Office Action Summary	Application No. 10/521,740	Applicant(s) GLAUBITZ, ROBERT MANFRED	
	Examiner Mr. Terry K. Cecil	Art Unit 1723

DETAILED ACTION

FIG. II

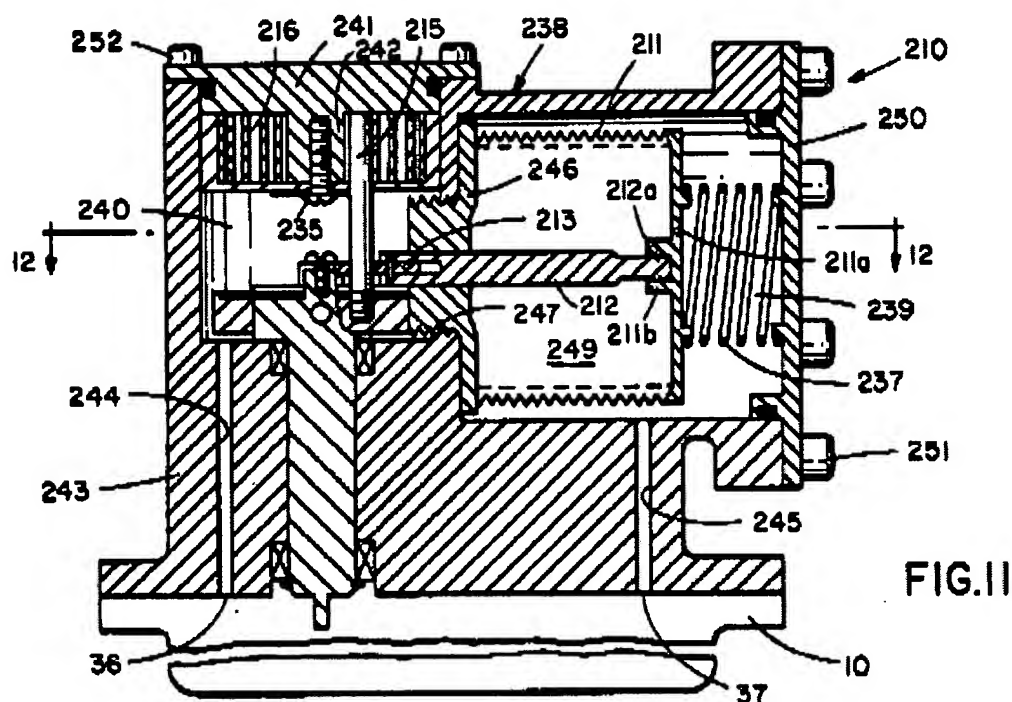
8. Claims 1, 12 and 14 are rejected under 35 U.S.C. 102(b) as being clearly anticipated by Winzen (U.S. 4,054,521).

See also cols. 7-8 and figures 12-15.
